LAWRENCE COUNTY

Re: North Sand Project Comments

Lawrence County Comments on BHNF North Sands Project

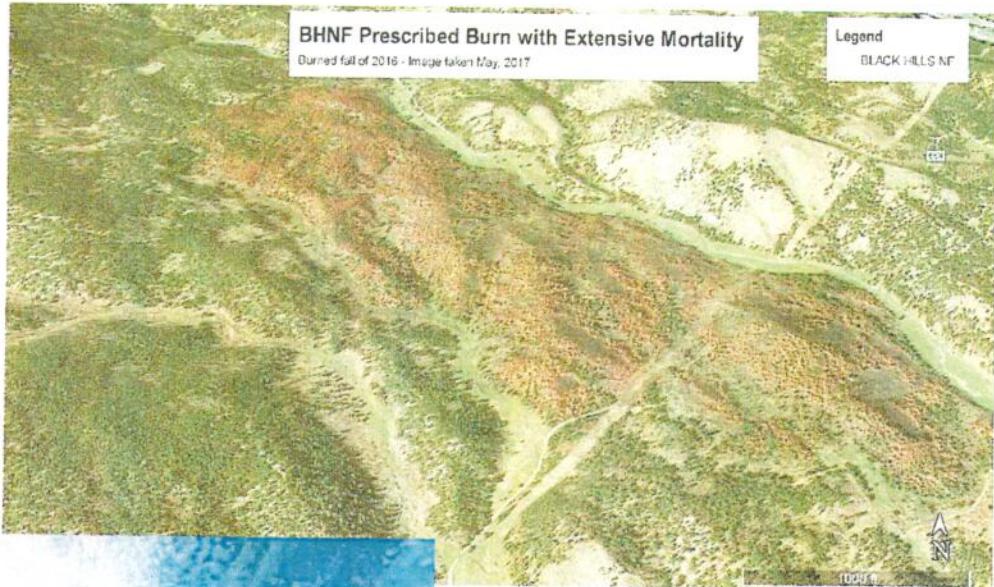
We are concerned about the amount and type of prescribed burning that is proposed. By our calculations, the North Sand project would treat roughly 50% (5,424 acres) with prescribed burning. Of this total only 1,047 acres will be commercially pretreated and another 1,140 acres non-commercially pretreated. We recommend adding project design criteria that we require that all stands or areas planned for prescribed burning will be pretreated commercially or noncommercially. This is very important since prescribed burning is not very selective and the Forest Service has not demonstrated an ability to manage the impacts to vegetation from prescribed burning in the Black Hills NF. There have been many cases in the Black Hills NF where the goal of burning was to reduce the dead and down fuels and the prescribed burn kills much of the overstory, which then results in more dead and down trees and fuel loading than what was on the site before the burn. Below, is a 2017 Google Earth photo of a 2016 prescribed burn in the Black Hills NF which resulted very high tree mortality. The next photo was taken in 2022 and shows that this area is now pretty much a brush and weed field with high amounts of dead and down fuels.

The photo above is of prescribe burn that killed a large patch of timber resulting in significant wildland fuel (slash) on the ground

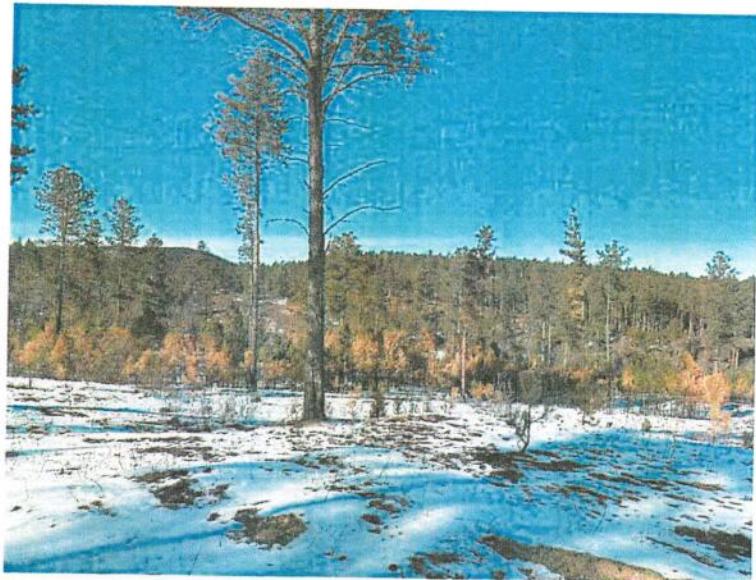
prescribed burning than with mechanical treatments. This also applies when the Forest Service attempts to use prescribed burning to try to thin regeneration. In the picture below of a recent prescribed burn almost all of the regeneration has been killed by the burn under what appears to be a seed cut. This does not make any sense. The whole reason for applying the seed tree cut is to establish a successful stand of young trees, which in this case was successful. But then the Forest Service used a prescribed burn, instead of a mechanical precommercial thin, to try to thin the regeneration, with disastrous results.
